***ADDENDUM***  
***TO***  
***FUNCTIONAL SERVICING REPORT***

**HILLSBURGH HEIGHTS INC.**  
**PROPOSED RESIDENTIAL SUBDIVISION**

**5916 TRAFALGAR ROAD NORTH**

# **1. RESPONSES TO THIRD SUBMISSION COMMENTS RELATING TO STORMWATER MANAGEMENT**

**SEDIMENT DRYING AREAS**  
1:1000

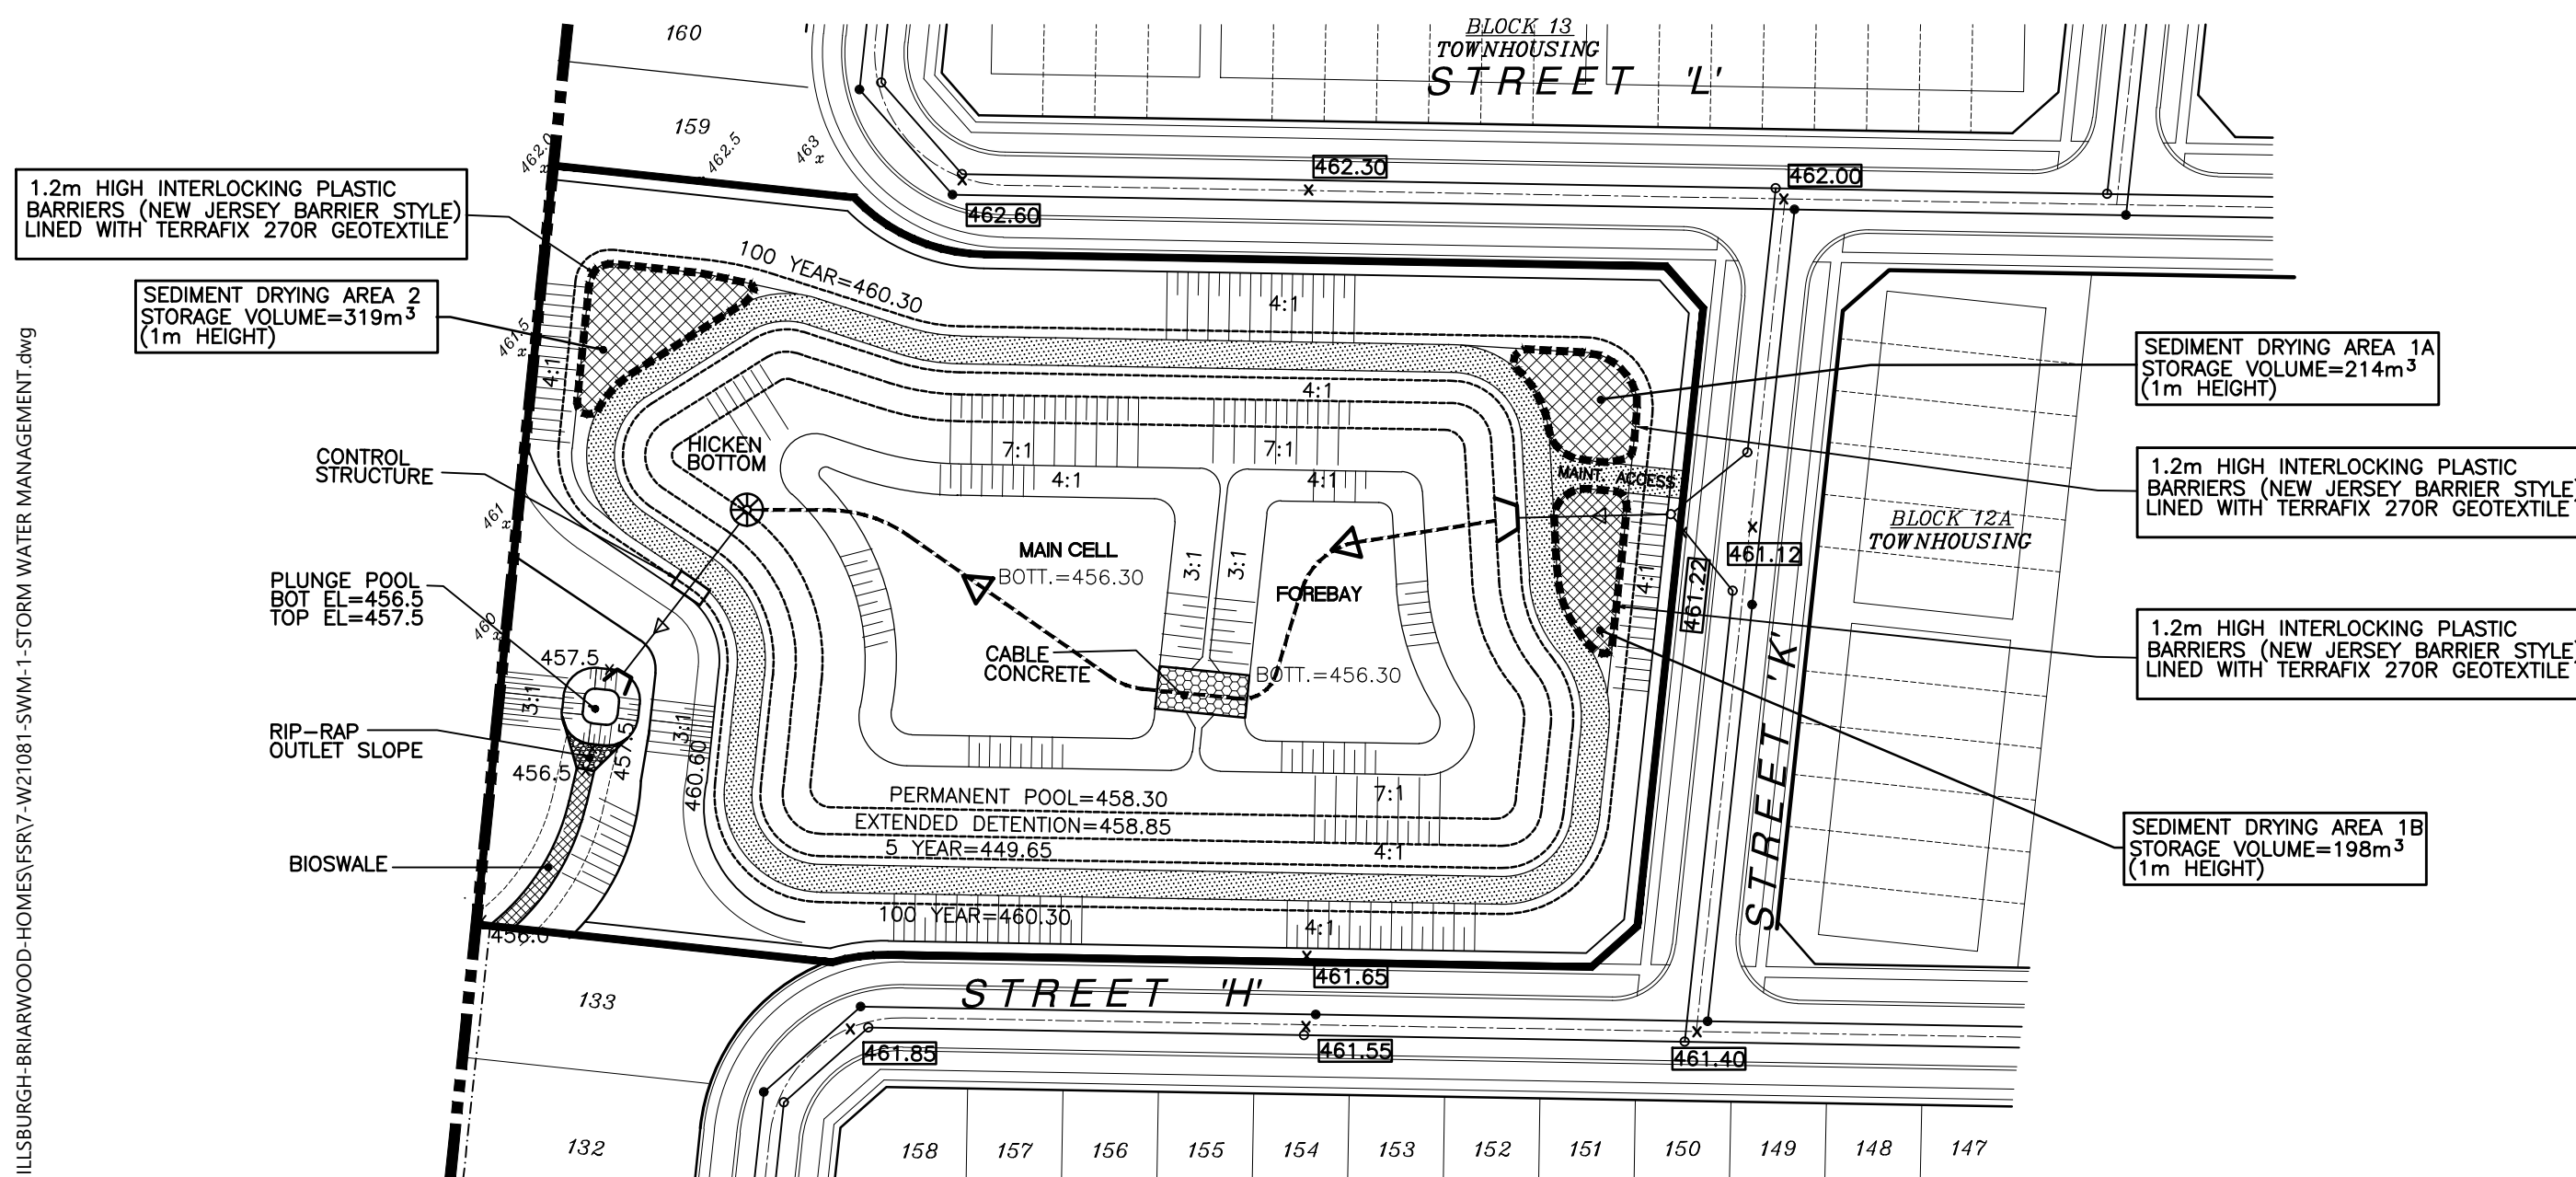
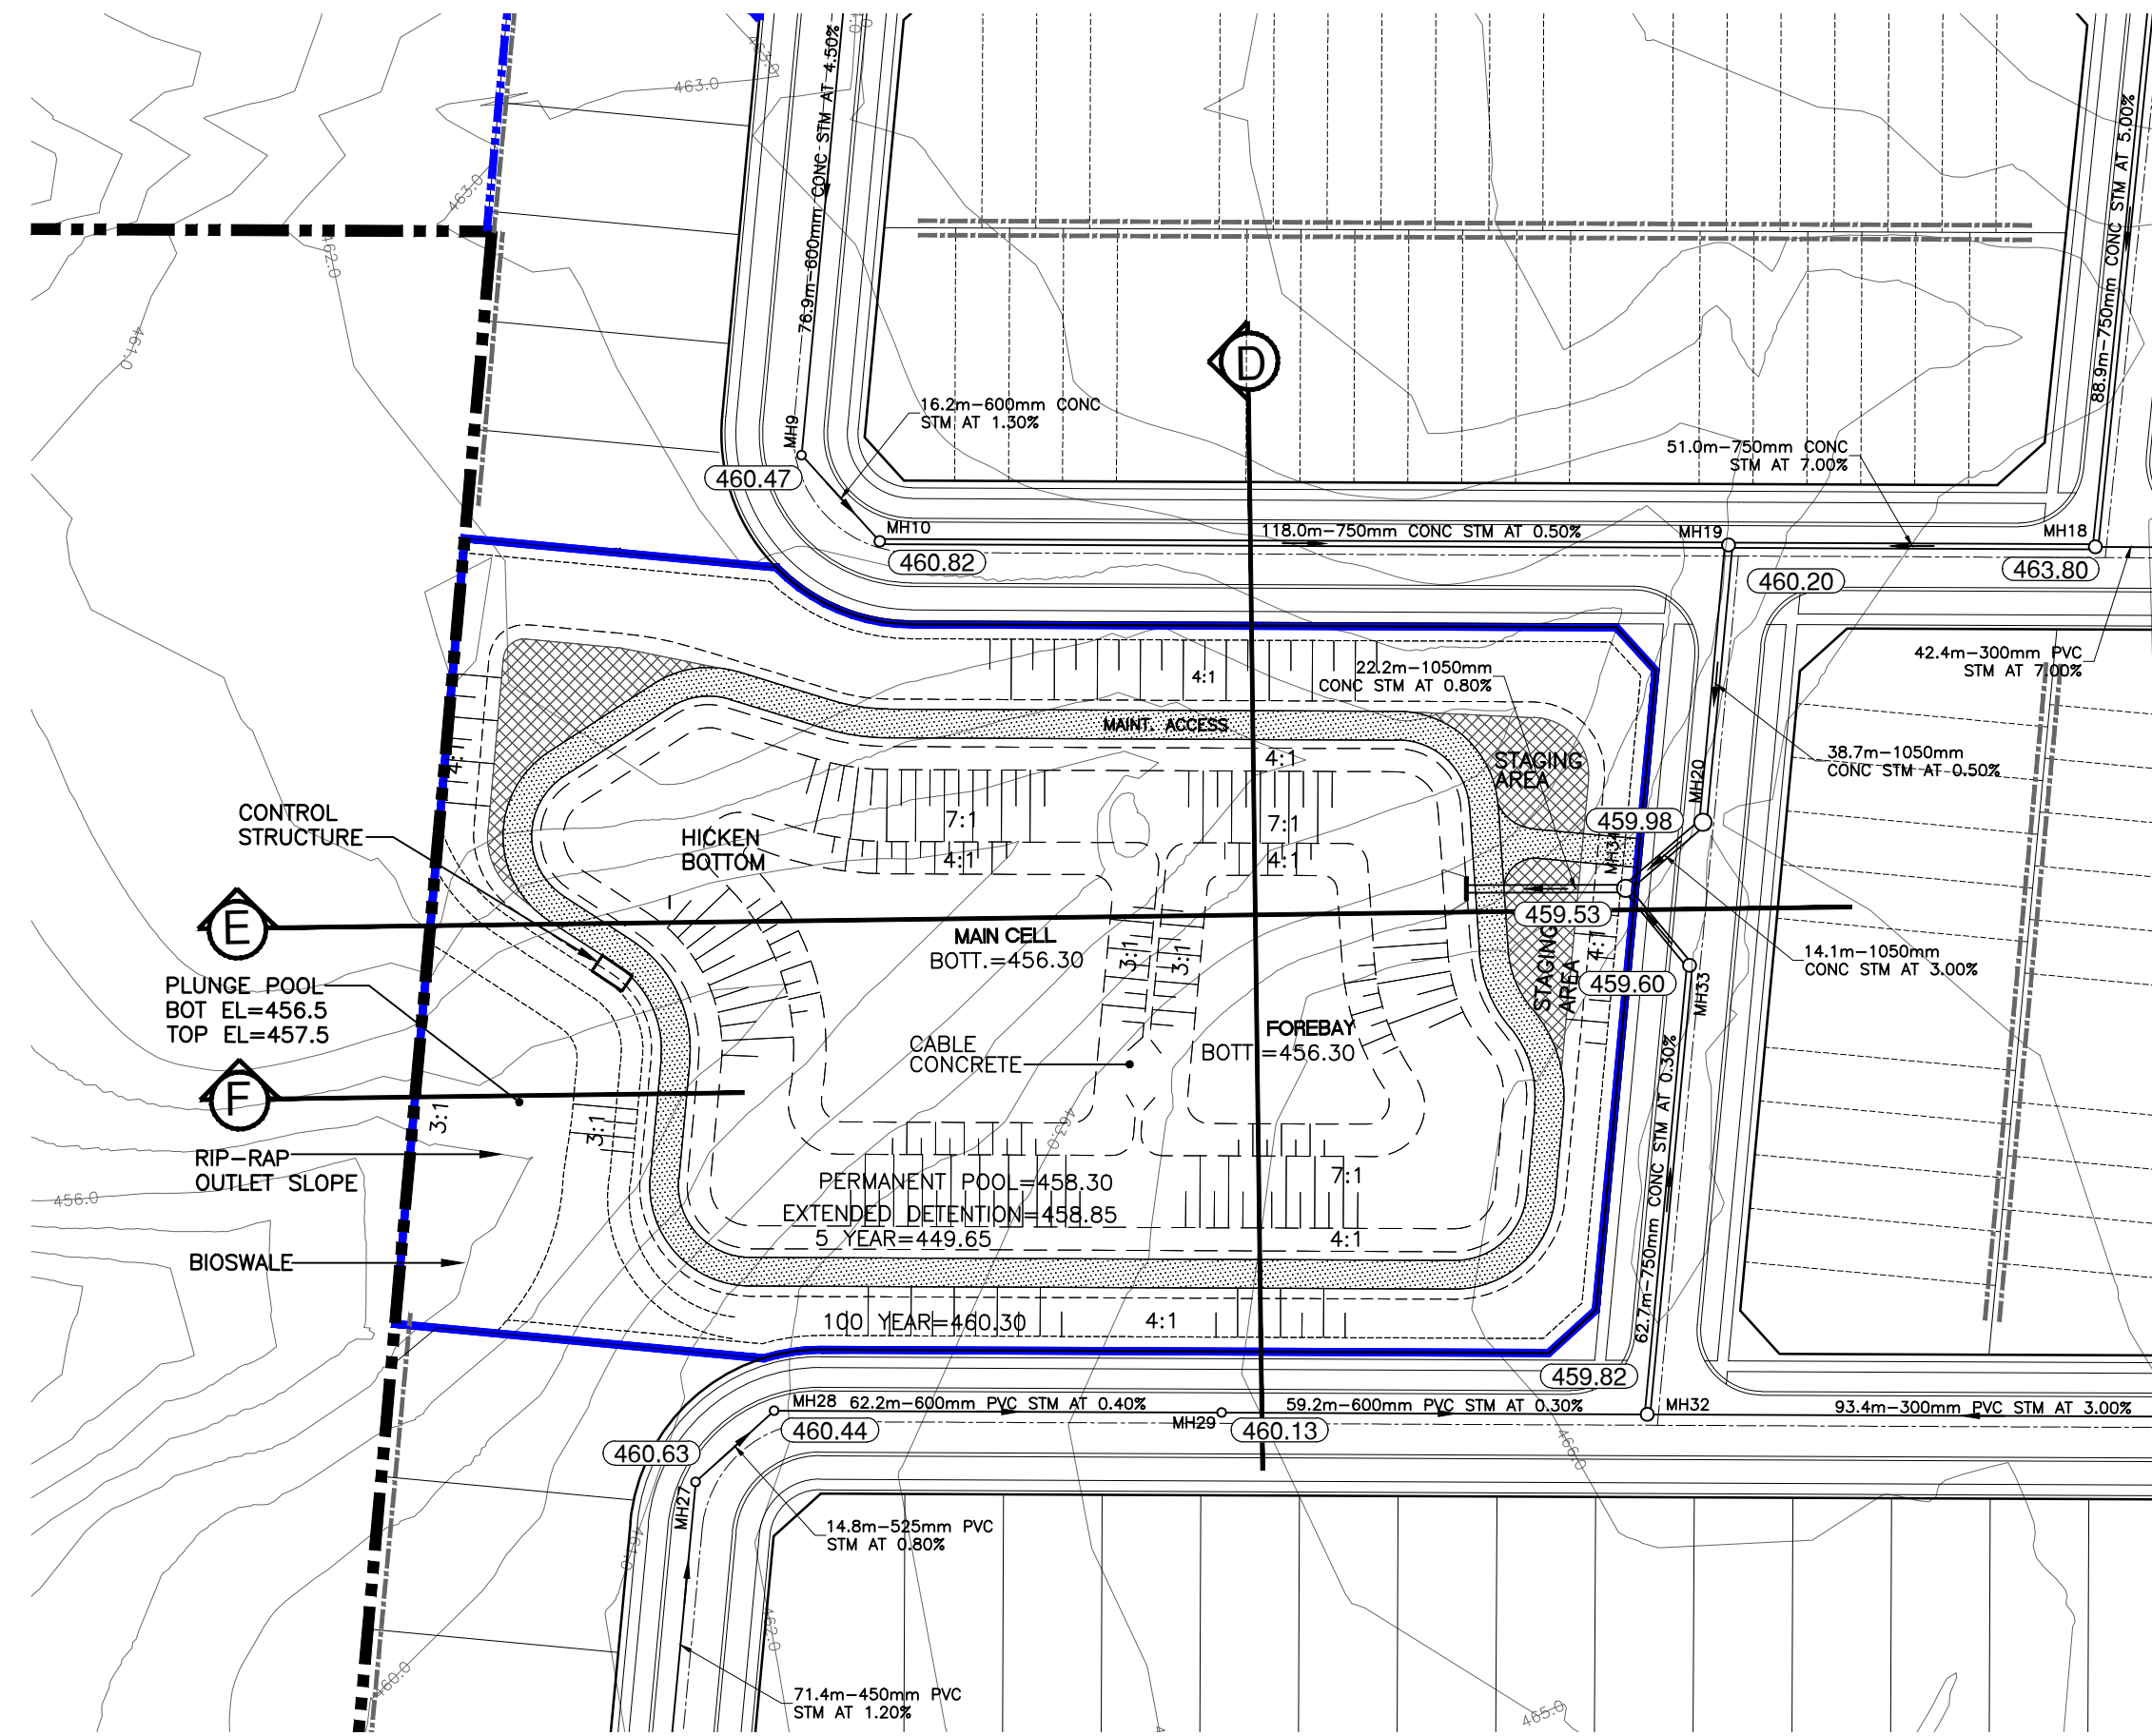
### **13. Sediment Drying Areas in SWM Ponds**

Notwithstanding that sediment drying areas are not used by Contractors for removing sediment from SWM ponds, as required by the Town sediment drying areas are shown on SWM Pond Drawing SWM-1 Rev. 3 and SWM-2 Rev. 3.

Refer to the attached Appendix II for the sediment drying areas storage volume calculations. A storage area of 530m<sup>2</sup> is provided in SWM Pond No. 1 (east) and an area of 467m<sup>2</sup> is required. A storage area of 731m<sup>2</sup> is provided in SWM Pond No. 2 (west) and an area of 458m<sup>2</sup> is required.

Storage Capacity as per Drawing SWM-2 =  $731\text{m}^3$
